Item ID: D3016-041 Accept ***N900040100*** Setup Start ***NS1***
 Revision ID: Stop ***NS2***
 Item Name: Seat Frame Assembly
 Start Date: 12/15/2014 Start Qty: 1.00 ***1*** Cust Item ID:
 Required Date: 12/31/2014 Req'd Qty: 1.00 ***1*** Customer:
 Reference:

DRAWING NO. D3016	TITLE SEAT FRAME ASSEMBLY	REV. A	DART AEROSPACE LTD ENGINEERING ORDER	D.E.O. NO. D3016-A-1	SHEET NO. SHEET 1 OF 1	SCALE NTS
DRAWN <i>1</i>	CHECKED <i>UP</i>	MFG. APPR. <i>BE</i>	APPROVED <i>MP</i>	DE APPR. <i>MP</i>		
DATE 10.01.29	DATE 10.01.29	DATE 10.01.29	DATE 10.01.29	DATE 10.01.29

TO REVISE D3016-11 SADDLE'S HOLE SIZES

D3016-11 SADDLE

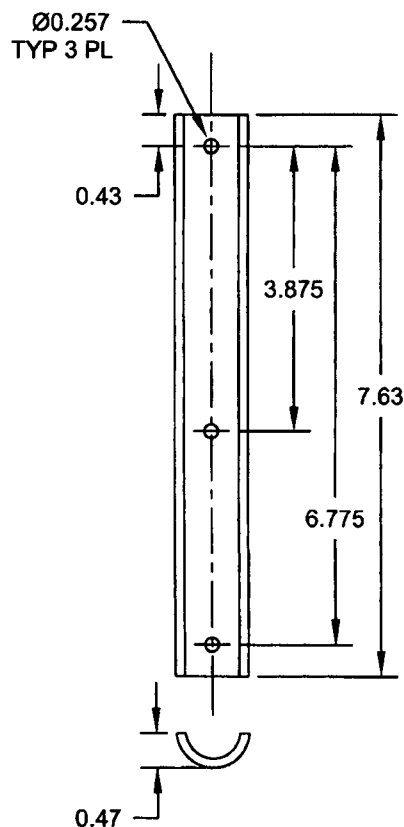
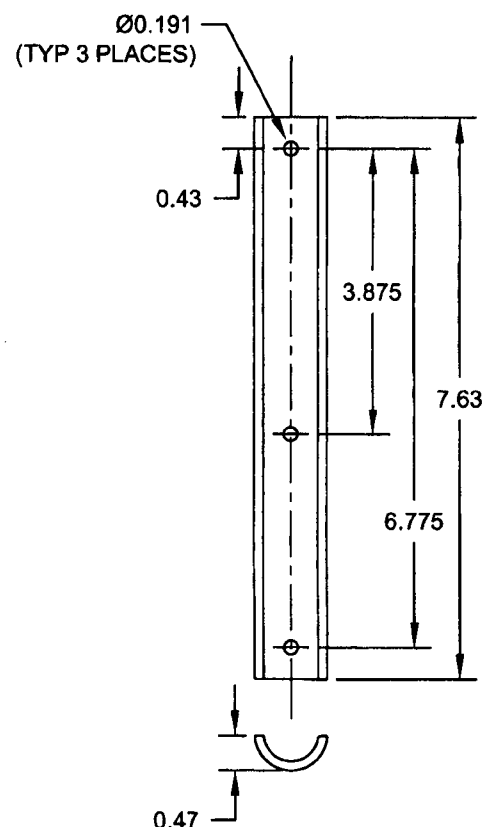
DETAIL D3016-11 SADDLE (SHEET 3): Ø0.257 TYP 3 PL WAS Ø0.191 (TYP 3 PLACES) AS SHOWN:
